Re: SSD 7733 Penrith Resource Recovery Facility - Response to Matters Raised by Penrith Council

Subject: Penrith Resource Recovery Facility - Response to Traffic Matters Raised by Penrith City Council

Figure 1 Existing traffic volumes

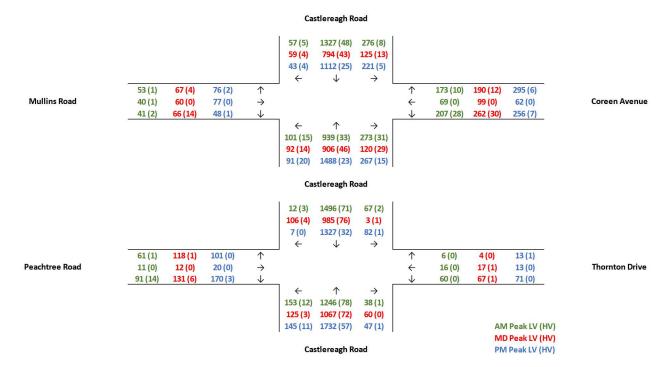
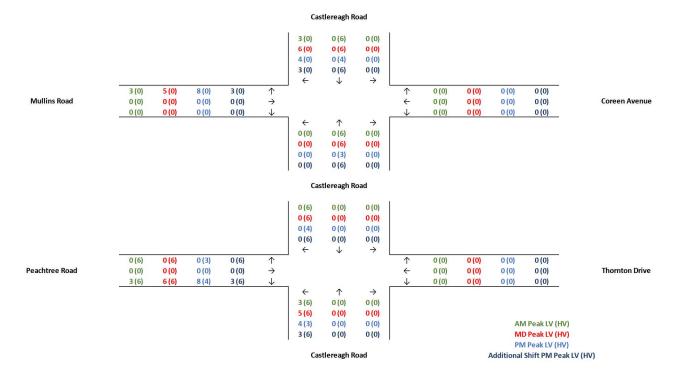
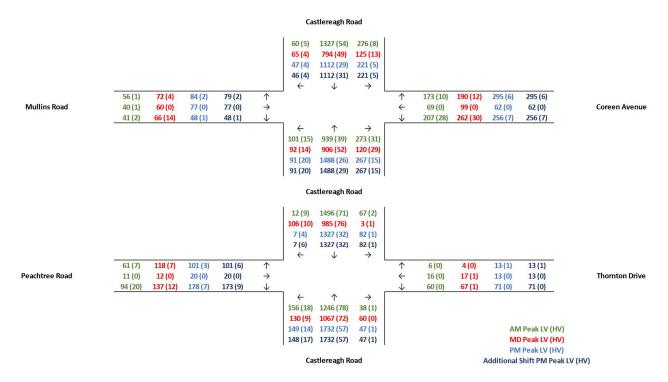
"The primary remaining concern that is yet to be resolved is the Level of Service (LOS) F that has been identified in the application for the western leg of the intersection of Peachtree Road with Castlereagh Road. If the Department is of a mind to support the application, this support should be predicated on traffic infrastructure works that sufficiently resolve queue lengths and time delays as identified in the traffic modelling submitted. The RMS commentary will relate to the classified roads under their care and control, whereas Council must separately ensure that our local road network is not further compromised or impacted by the proposal on this site, in this location.

The applicant's response to date is that it is considered accepted practice to only look at overall intersection performance (rather than individual legs) in terms of Level of Service. This is not considered to be an adequate response and does not resolve or address the concerns raised by Council. It is recommended that the Department ensure that the failure of the western leg of the intersection is sufficiently addressed and measures included within this application, or as conditions of consent, that ensure that the existing volumes/local road function are not worsened as a result of this intensified development. If such measures are not proposed or included, the question of suitability of the site to accommodate this scale and nature of development comes into question, being a key consideration within Section 4.15 of the Environmental Planning and Assessment Act, 1979."

For clarity, the existing traffic, additional traffic and development traffic detailed in the Traffic Impact Assessment (TIA) (prepared by EMM Consulting in May 2017 to accompany the Penrith Waste Recycling and Transfer Facility Environmental Impact Statement) are presented in Figure 1, Figure 2 and Figure 3 respectively. The development traffic is obtained by summing the existing traffic and additional traffic. The numbers unbracketed represent light vehicle volumes in the respective peak hours while the numbers inside the brackets represent heavy vehicle volumes.

As the development right turn movement from Peachtree Street is LOS D or better for all the traffic peak periods considered, no intersection upgrade work is required as a result of the proposed development.

Swept paths

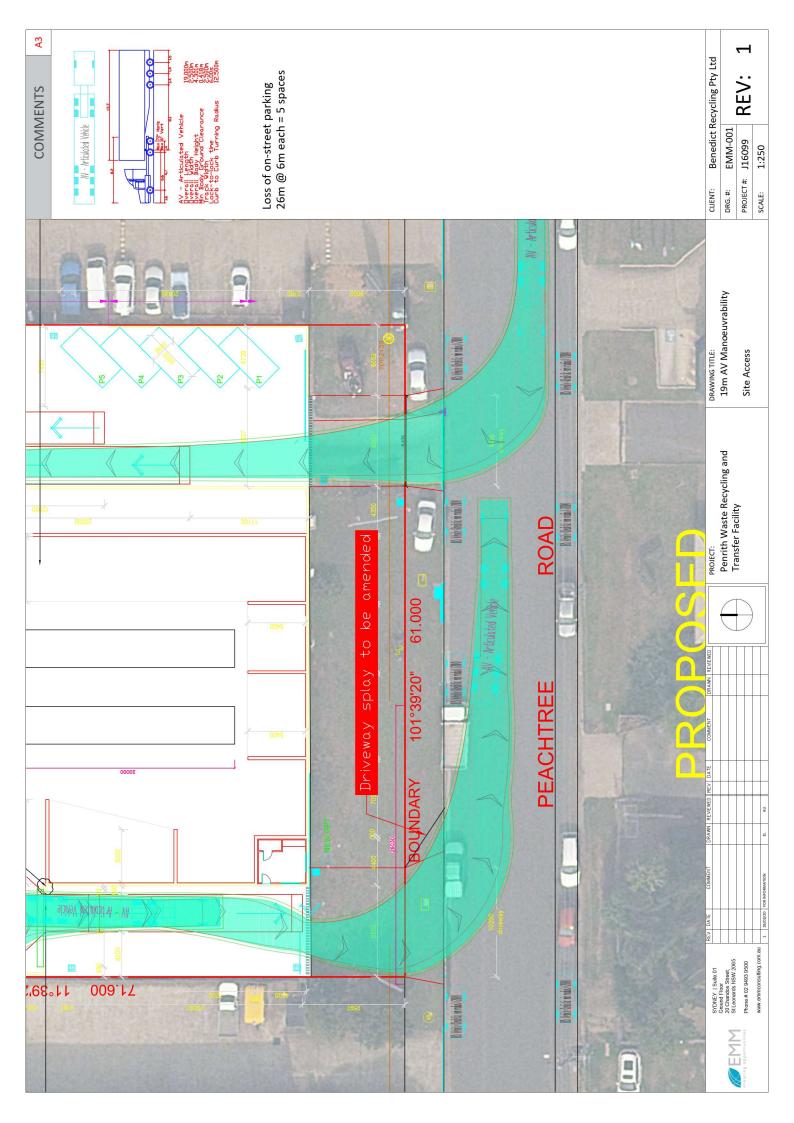
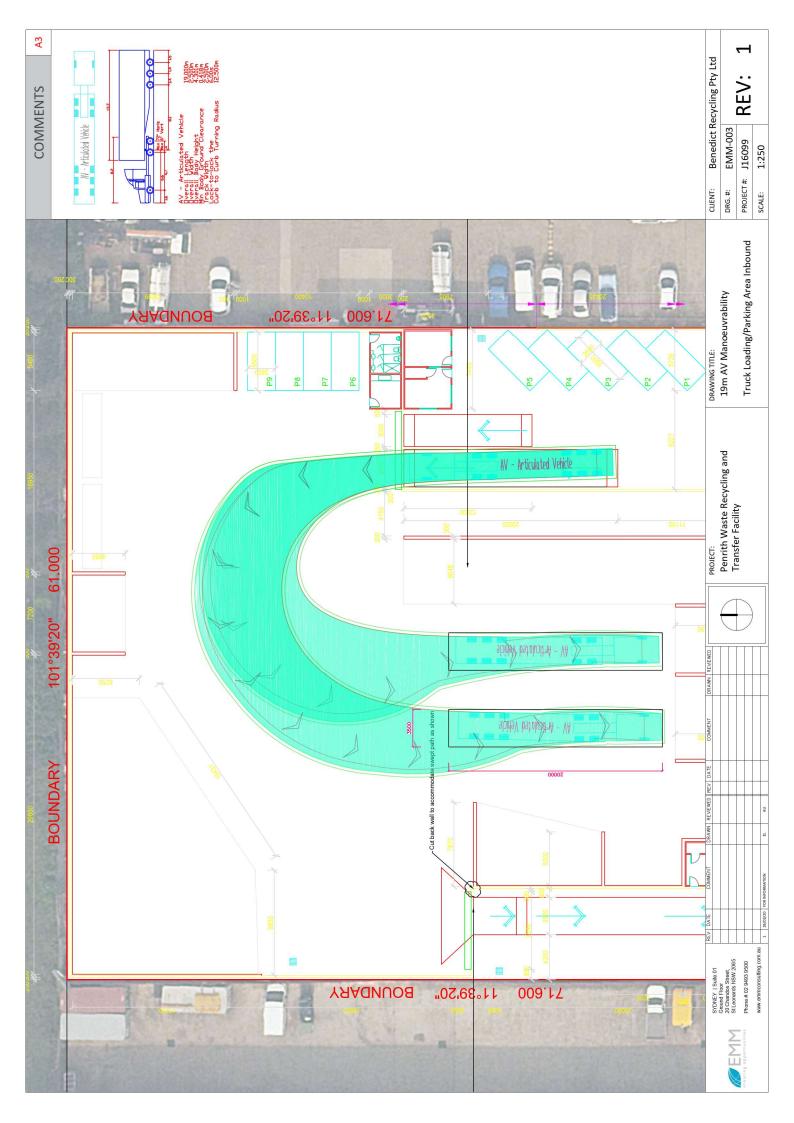
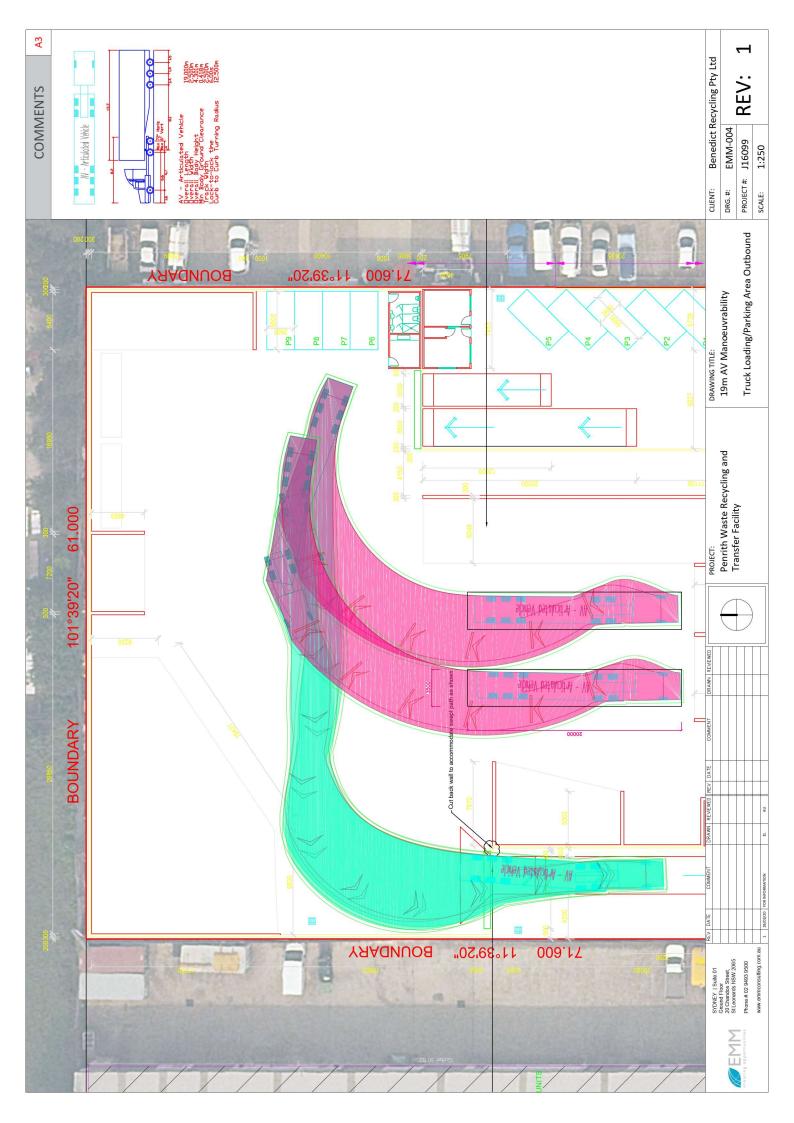
"Council maintains its position that the driveway must be widened to satisfactorily facilitate truck turning swept paths clear of parking lanes, and clear of oncoming vehicles in opposing travel lanes. Amended plans reflecting this requirement should be submitted that demonstrate compliance with this requirement."

"The application appears to now indicate that no formalised truck parking is line marked to be provided. It must be demonstrated that sufficient space on the site is available to accommodate sufficient on-site truck parking. It is not sufficient to remove indications of parking without demonstrating that parking available, without reliance on the local road network."

A swept path assessment has been undertaken (refer Appendix A) demonstrating truck manoeuvres can be appropriately accommodated without encroachment onto the opposing lane.

Formalised truck parking spaces have been provided near the stockpiles area in accordance with AS2890.2 and are shown in the swept path assessment (Appendix A). The assessment demonstrates adequate manoeuvrability of these spaces for 19 m articulated vehicles.
